PIMA COUNTY  
REGIONAL FLOOD CONTROL DISTRICT  
97 EAST CONGRESS STREET, THIRD FLOOR  
TUCSON, ARIZONA 85701-1797

**Re: Response to Second Incomplete and Incorrect Determination for Underground Storage Facility Application No. 71-563876.0006**

Figure 13  
 AS-BUILT DIAGRAM • PIEZOMETER HP-2  
 Pima County Regional Flood Control District

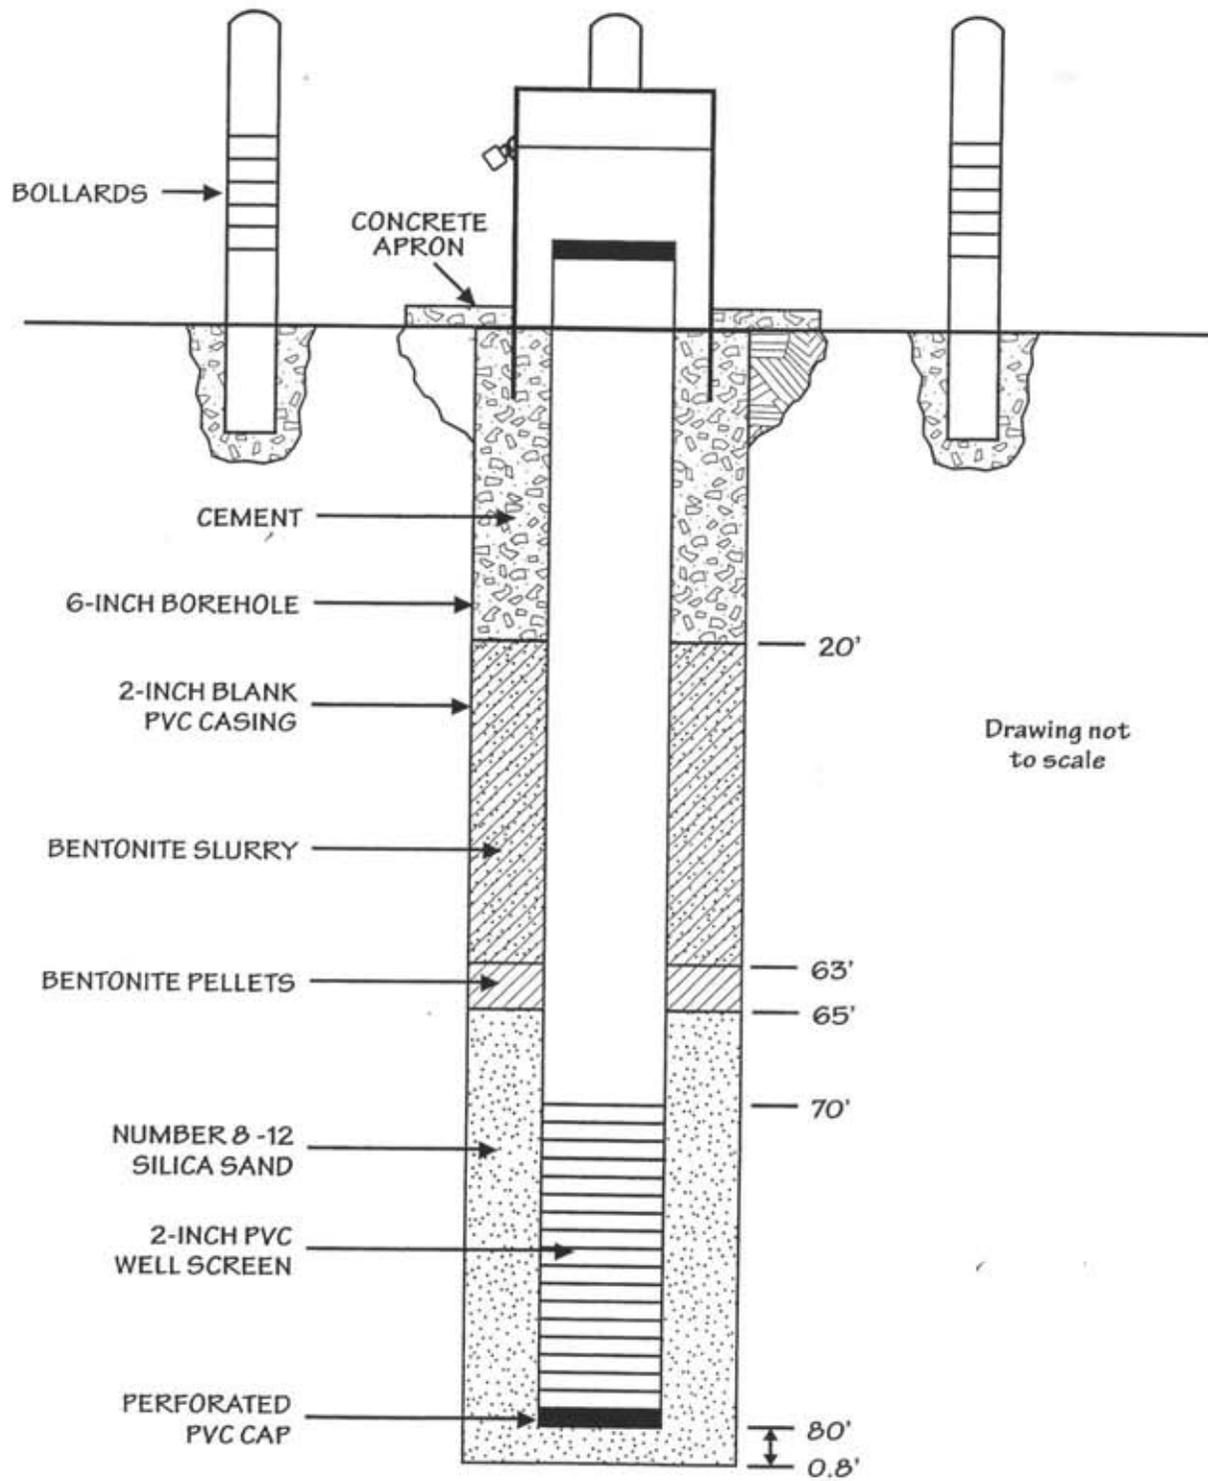
An as-built well diagram and well driller report are attached for well HP-2, as requested (**Attachment 1**).

## GRAPHIC LOGS OF ESTIMATED INFILTRATION CAPACITY FOR SEDIMENTS AT TEST PITS 7, 13 & 14

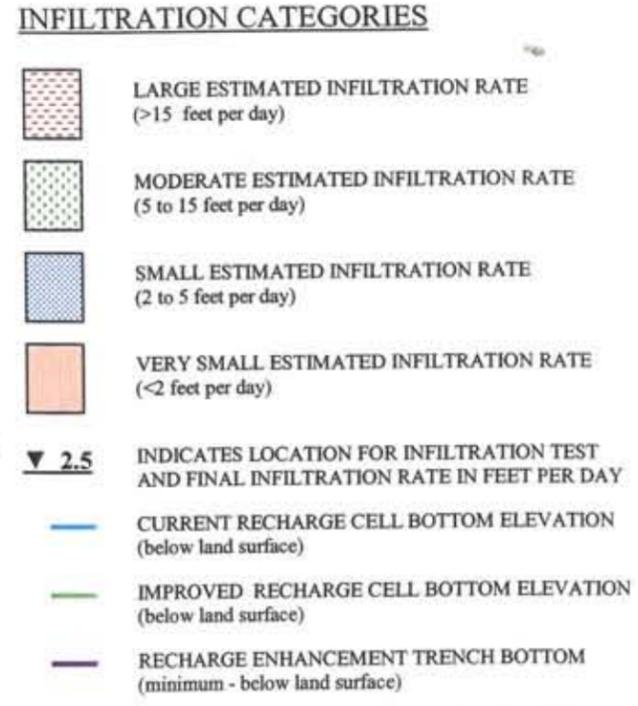
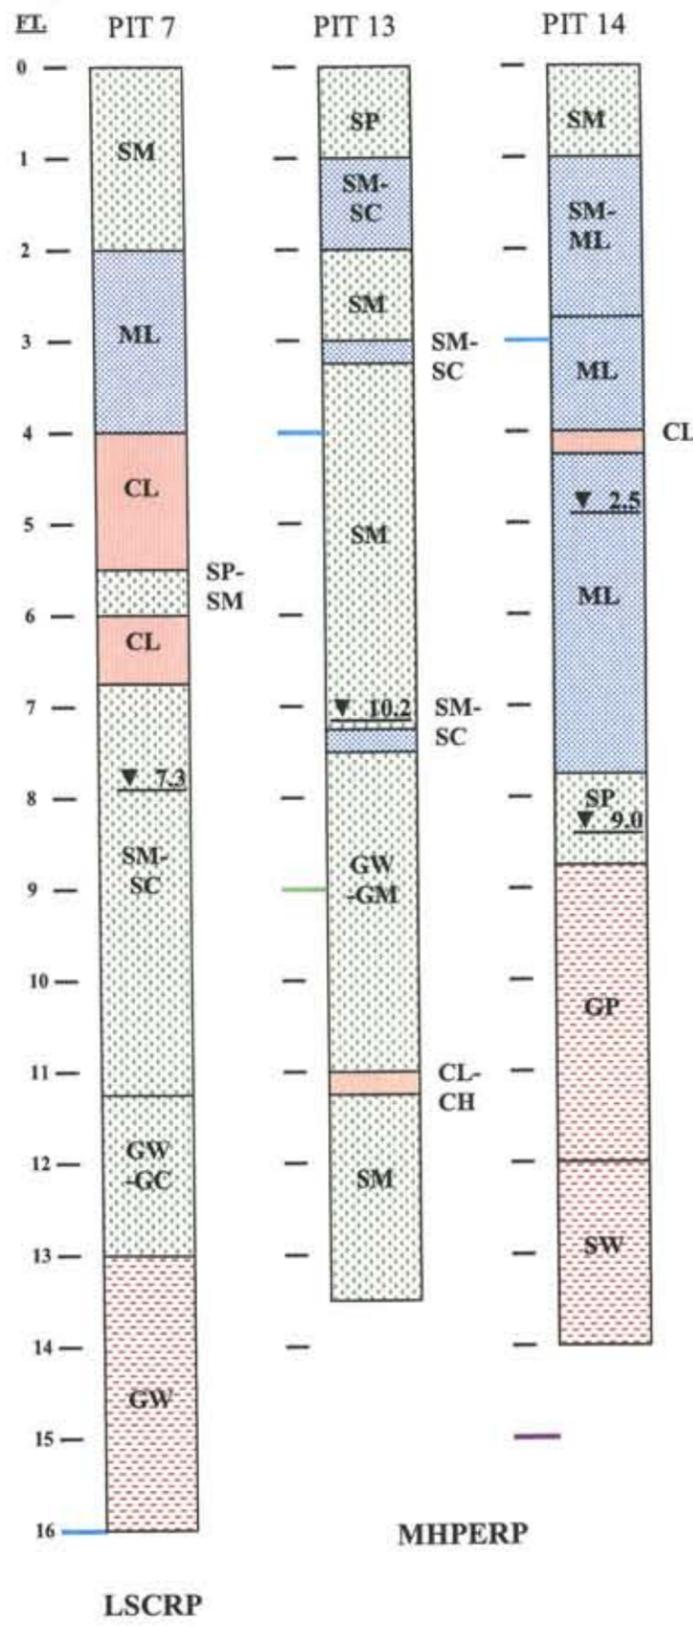
**Bullet #1:** Montgomery & Associates, Inc. completed a soils characterization and infiltration test study in 1996 for the Lower Santa Cruz Replenishment Program, which included two test pits located at the Marana High Plains Effluent Recharge Project (MHPERP) site and one test pit at the Lower Santa Cruz Recharge Project (LSCR) site. A summary of the soils characterization and infiltration test results is provided in **Attachment 2**, along with the approximate elevations of the basin bottoms as determined using the as-builts for the two projects. Based on this study, highly permeable, coarse-grained soils (gravel and sand mixtures) are present at depths of five feet below the bottom of Recharge Cell No. 2 and six to seven feet below the bottom of Recharge Cell No. 4. Gravelly soils were encountered at a depth of about 13 feet at the one test pit located within the LSCR site, which has a completed basin bottom elevation of 16 feet below land surface.
